# City of Sumter Design Review Board

## HP-24-10 424 W Calhoun St. (City)

**Request:** Request for Design Review Approval to replace wood front door with new steel door of a similar design, and to re-establish side sunroom/porch windows and doors.

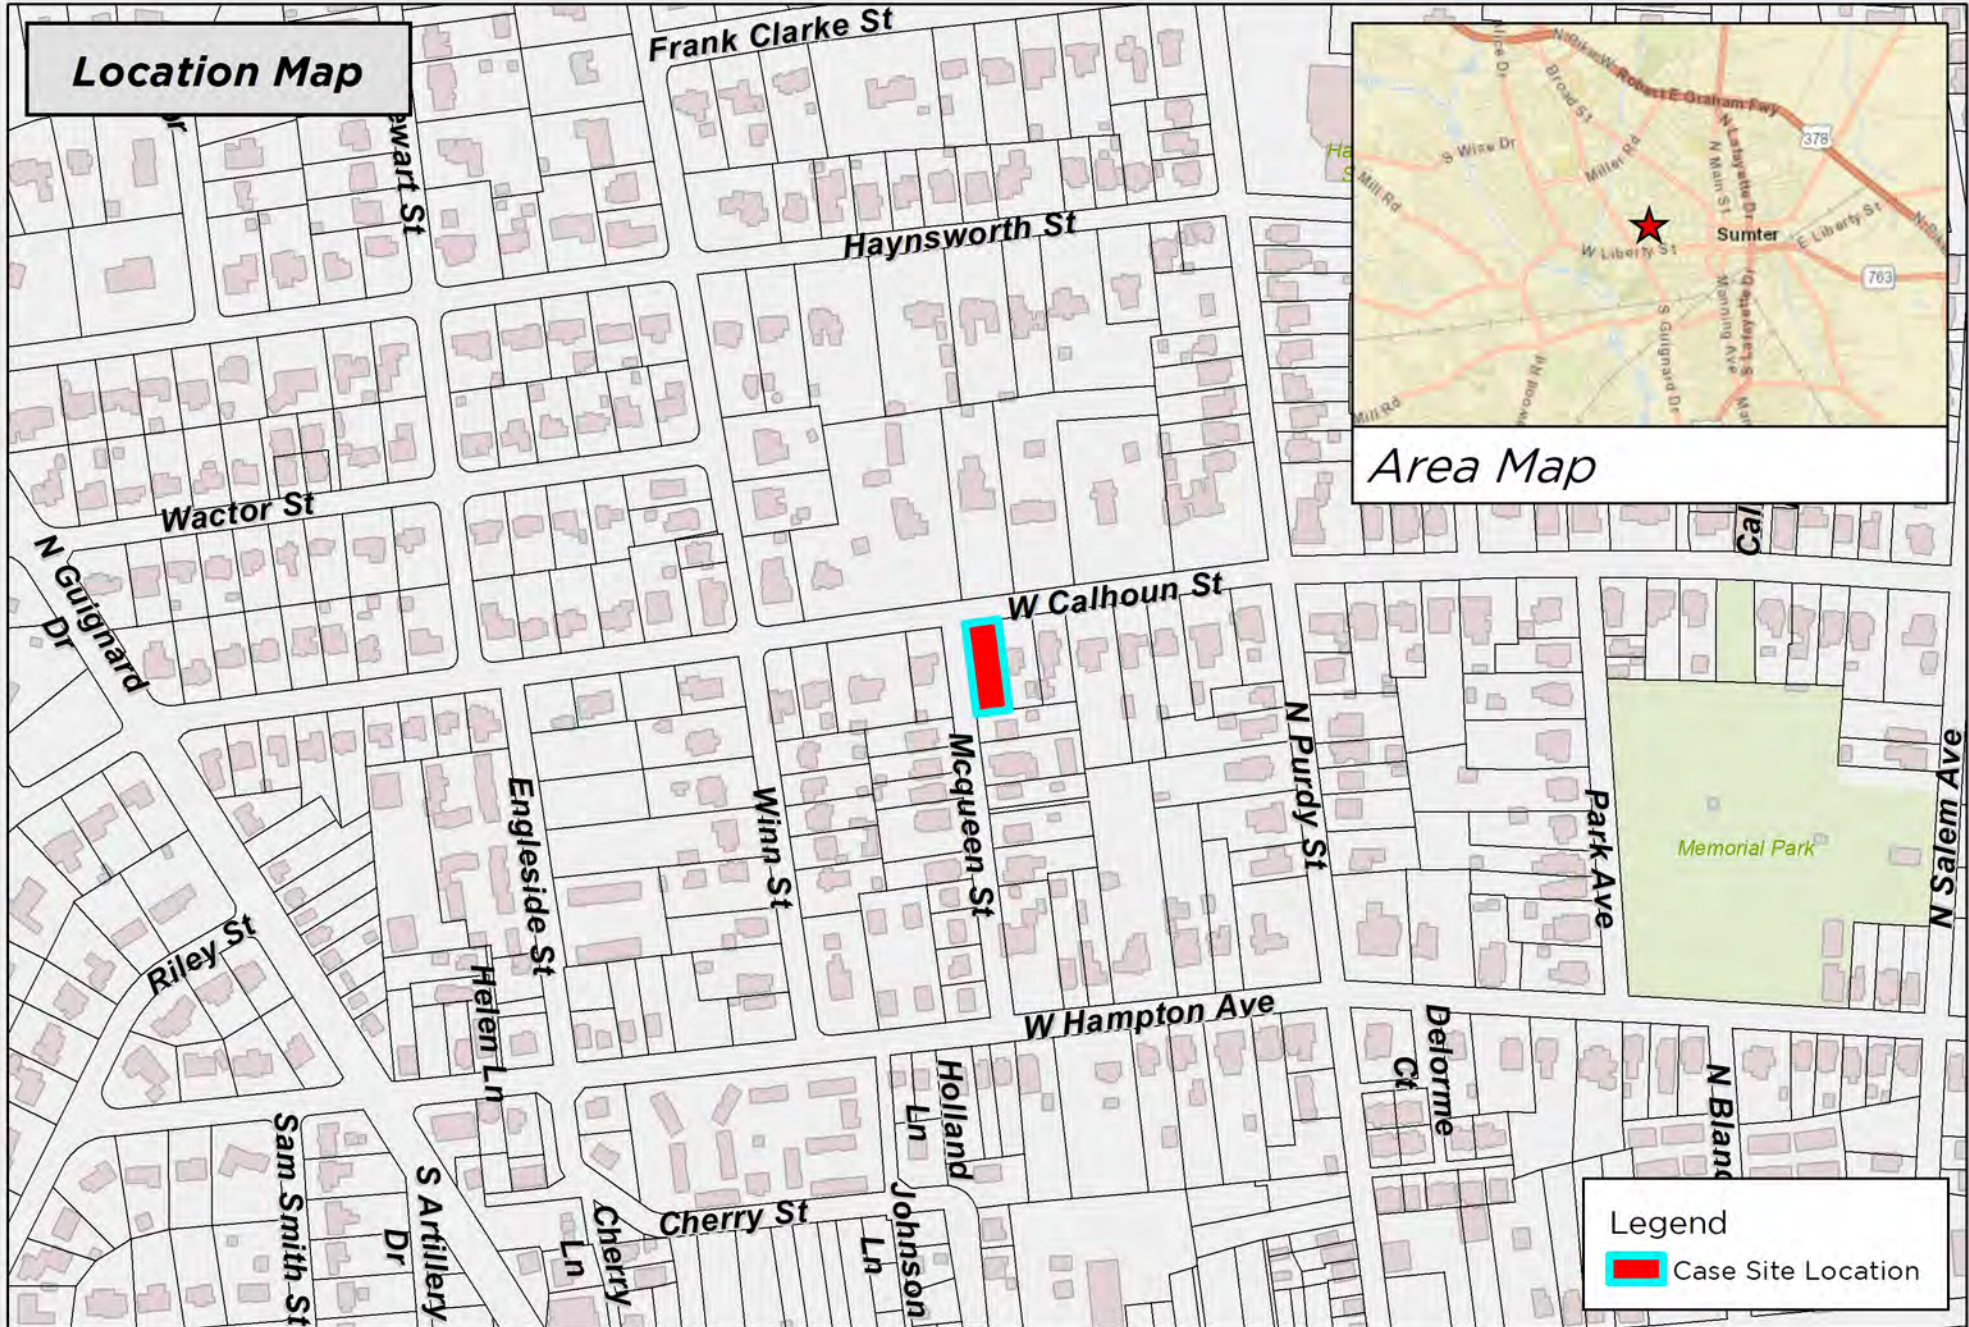
The applicant is proposing to replace the existing wood twelve lite door with a steel or metal fifteen lite style door of similar color, and is proposing to replace the half-circle transom above the door with a half-circle transom. The applicant's intent is to match style as much as possible using modern materials and styles.

The primary reason for replacement is that the current door's lifespan is ending, and the door is experiencing significant threshold rot and has become a security issue.

Staff recommends **Approval** of this request. The proposed alterations are consistent with the Design Approval Guidelines and are in keeping with the architectural style of the home and the period in which it was constructed.
